Item Name: Baggage Compartment Protector - Floor

Work Order ID 164855

DART SERVICE INSTRUCTION

TO AMEND INSTALLATION INSTRUCTIONS IIN-D407-781-2 REV. A OR LATER APPROVED REVISION
AND INSTRUCTIONS FOR CONTINUED AIRWORTHINESS ICA-D407-781 REV. 3 OR LATER REVISION

**FIGURE 1 - D3879-1 BAGGAGE COMPARTMENT WALL
PROTECTOR - ALTERNATE INSTALLATION**

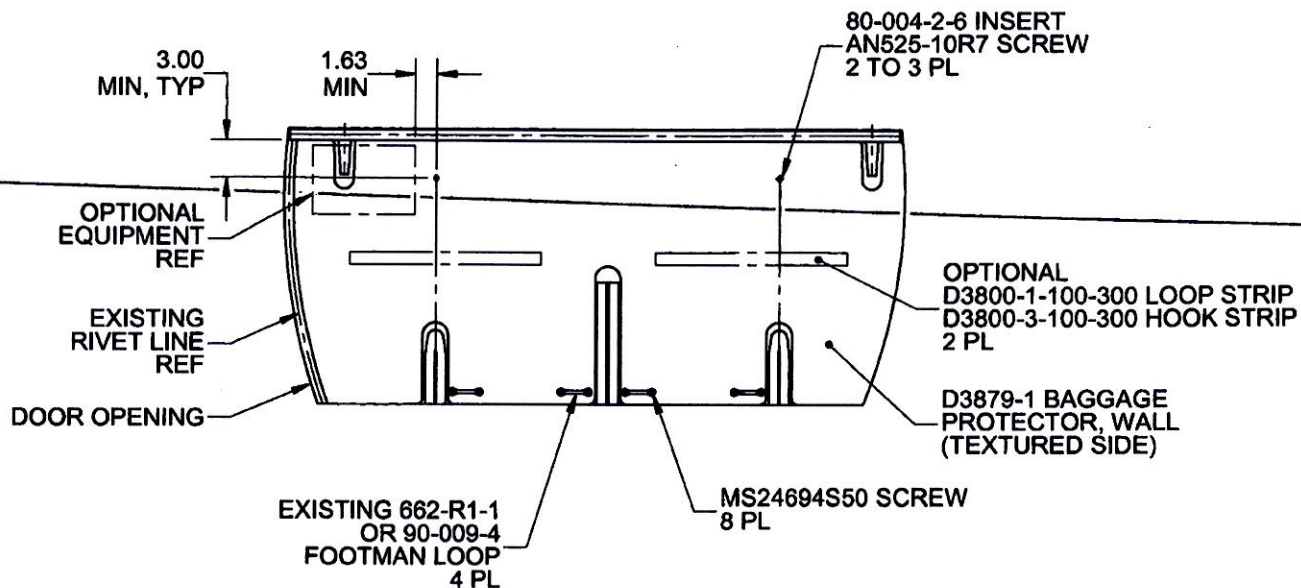
In some aircraft, the top portion of the D206-781-041 Baggage Compartment Wall Protector Kit cannot be installed as indicated in IIN-D407-781-2. The purpose of this DSI is to provide an alternate mounting method to fasten the top portion of the D206-781-041 Baggage Compartment Wall Protector Kit.

It is acceptable to replace qty(2) D3930-1 Clips with qty(2) 80-004-2-6 Inserts. Locate and mark location of the two attachment holes on the baggage compartment wall as shown in Figure 1 of this service instruction. Install 80-004-2-6 Inserts at the marked locations in accordance with Section 3-2-12 of BHT-206-SRM-1. It is acceptable to trim the wall protectors to accommodate optional equipment or transfer attachment holes to the wall protector and install the optional equipment on top of the wall protector with longer fasteners.
